Groundwater Application Review Summary Form

Application # G- 19395

GW Reviewer Stacey Garrison Date Review Completed: 4/27/2024

PUBLIC INTEREST REVIEW FOR GROUNDWATER APPLICATIONS

Theis Interference Analysis
POA 1

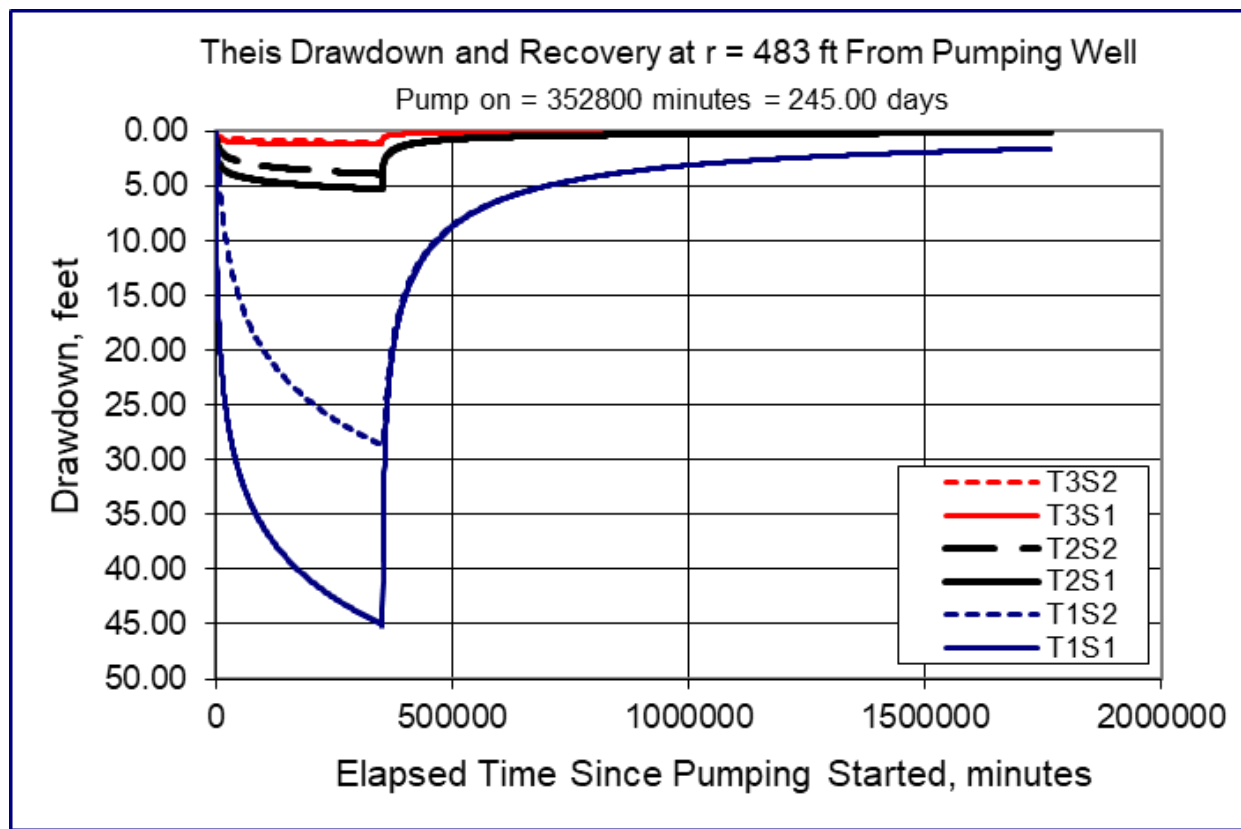
location of a well. It is likely the proposed use would cause some degree of well-to-well interference with the well that serves tax lot 100. To assess the degree of drawdown, a Theis drawdown analysis was conducted for the proposed use (see attached Theis Drawdown Analysis-POA 1). Results indicate that the proposed use is not likely to cause well-to-well interference with the well that serves tax lot 100 that exceeds the threshold under the standard condition for alluvial aquifers in the Willamette Basin.

Radial distance from pumping well (r)=483 ft [estimated radial distance to nearest groundwater user, tax lot 100]

Pumping Rate (Q)= 0.073 cfs (~32.8 gpm)*

Aquifer Transmissivity (T_1)= 526 gpd/ft (70.4 ft²/day), (T_2)= 6,253 gpd/ft (836 ft²/day), (T_3)= 32,056 gpd/ft (4,286 ft²/day)

Storativity (s_1) = 0.0003, (s_2) = 0.003 [Conlon et al 2005, Table 1 values for Middle Sedimentary Unit, MSU]

Total pumping time=245

*The full pumping rate could not be utilized continuously for the entire 245-day period of use without exceeding the 35.5 ac-ft maximum allowed duty. For the maximum allowed duty of 35.5 ac-ft, continuous pumping would occur for 245 days at a rate of 0.073 cfs (~32.8 gpm).

Based on this analysis of the available data and under the assumptions previously identified, groundwater for the proposed use is likely within the capacity of the resource; if a permit is issued for this application, the conditions in B1(d)(i) and B2(c) are recommended to protect senior users and the groundwater resource.

POA 2

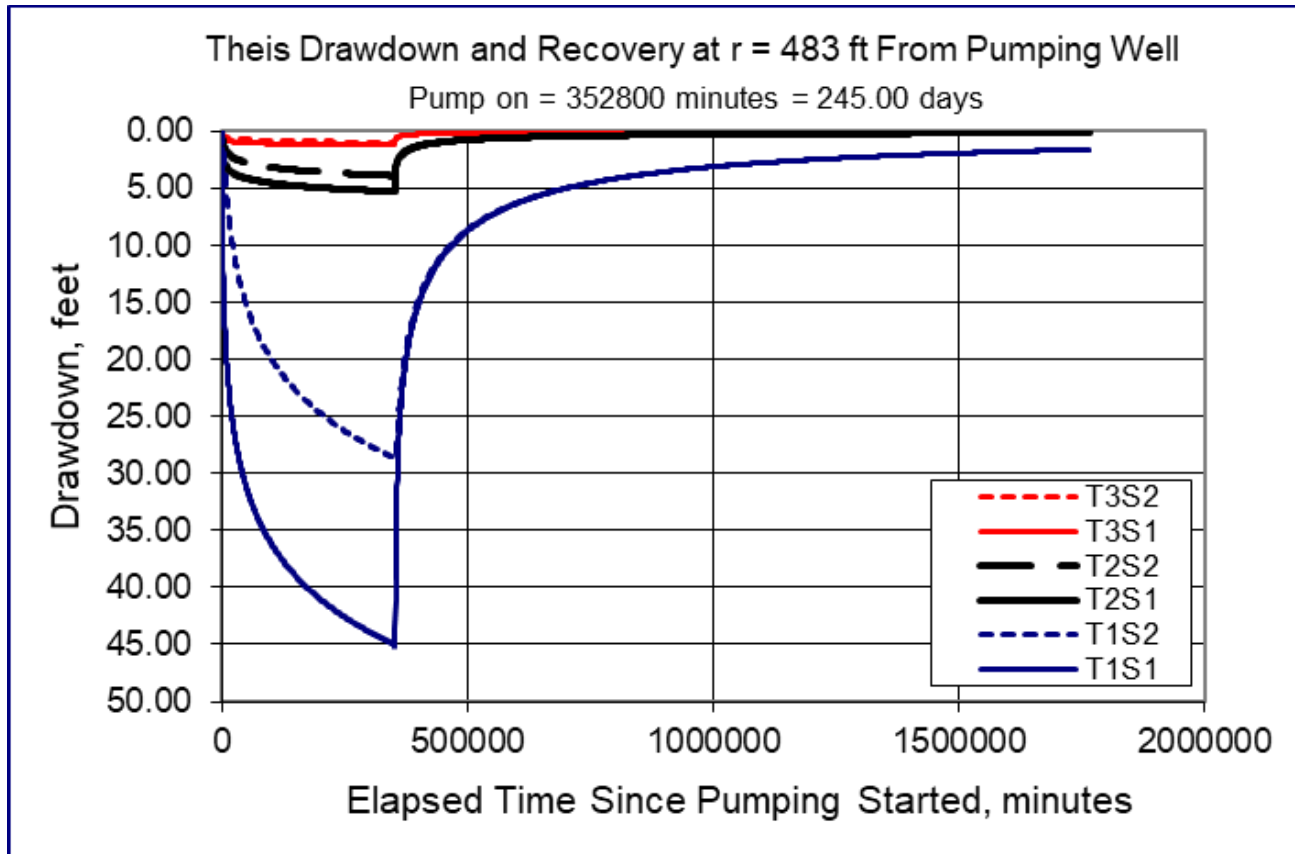
The nearest groundwater user to POA 2 is the domestic use well that serves tax lot 900 at 10320 S Barnards Rd, 743 ft southeast of the POA at an elevation of 257 ft msl. The approximate center of the developed portion of the tax lot was selected as the likely location of a well. It is likely the proposed use would cause some degree of well-to-well interference with the well that serves tax lot 900. To assess the degree of drawdown, a Theis drawdown analysis was conducted for the proposed use (see attached Theis Drawdown Analysis-POA 2). Results indicate that the proposed use is not likely to cause well-to-well interference with the well that serves tax lot 900 that exceeds the threshold under the standard condition for alluvial aquifers in the Willamette Basin.

Radial distance from pumping well (r)=743 ft [estimated radial distance to nearest groundwater user, tax lot 900]

Pumping Rate (Q)= 0.073 cfs (~32.8 gpm)*

Aquifer Transmissivity (T_1)= 526 gpd/ft (70.4 ft²/day), (T_2)= 6,253 gpd/ft (836 ft²/day), (T_3)= 32,056 gpd/ft (4,286 ft²/day)

Storativity (s_1) = 0.0003, (s_2) = 0.003 [Conlon et al 2005, Table 1 values for Middle Sedimentary Unit, MSU]

Total pumping time=245

*The full pumping rate could not be utilized continuously for the entire 245-day period of use without exceeding the 35.5 ac-ft maximum allowed duty. For the maximum allowed duty of 35.5 ac-ft, continuous pumping would occur for 245 days at a rate of 0.073 cfs (~32.8 gpm).
